PUBLIC INTEREST REVIEW FOR GROUNDWATER APPLICATIONS

TO: Water Rights Section Date June 8, 2016
 FROM: Groundwater Section Michael J. Thoma
 SUBJECT: Application G- 18187 Reviewer's Name
 Supersedes review of February 2, 2016

A. GENERAL INFORMATION: Applicant's Name: Erik Leib

Water-Level Trends in Nearby Wells

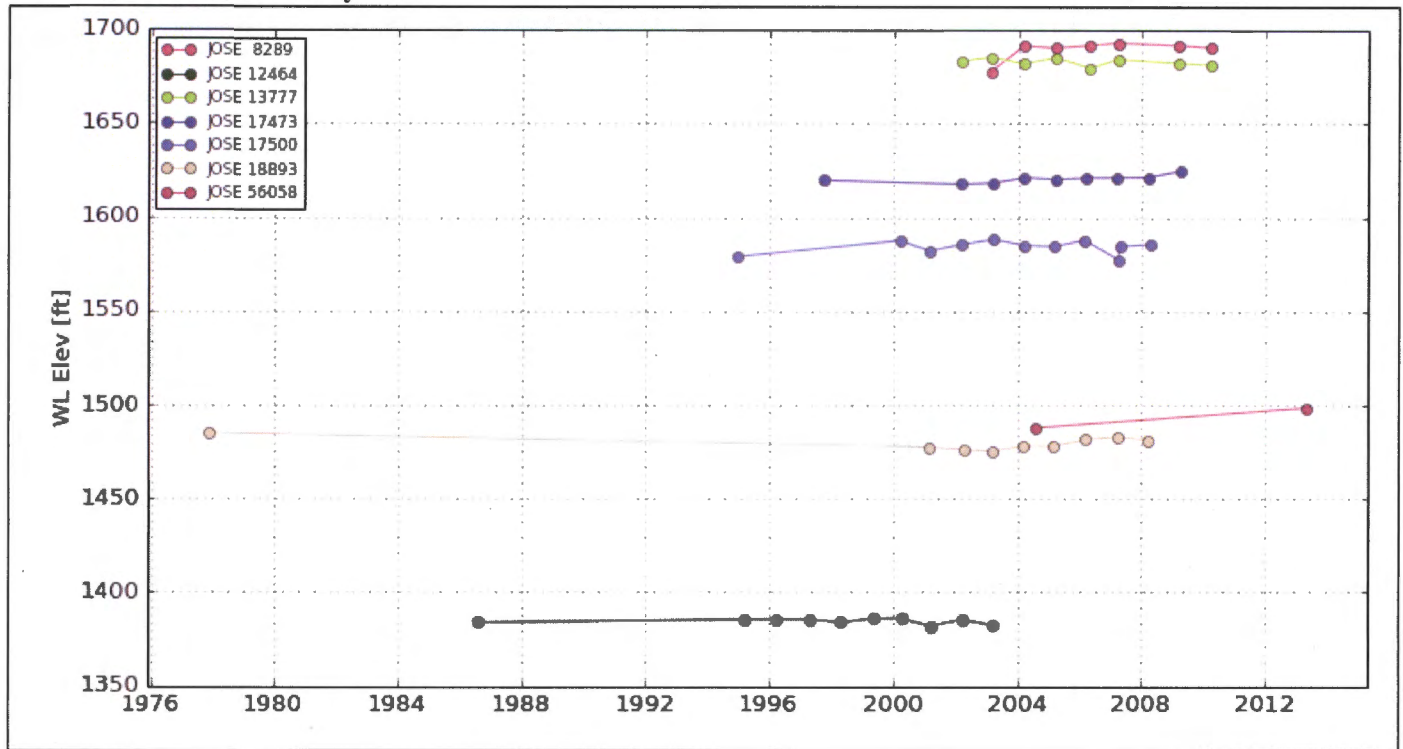
B3. **Groundwater availability remarks:** The applicant proposes groundwater production from a well completed in plutonic rocks (quartz-diorite and tonalite or "granitic"). This is considered a fractured-rock aquifer that is generally low-yielding, which has limited groundwater development in the area to primarily small-acreage irrigation and domestic use. There are a few OWRD observation wells located near the proposed wells and data from these wells show stable long-term groundwater levels, which is typical of the region (see attached water levels figure)
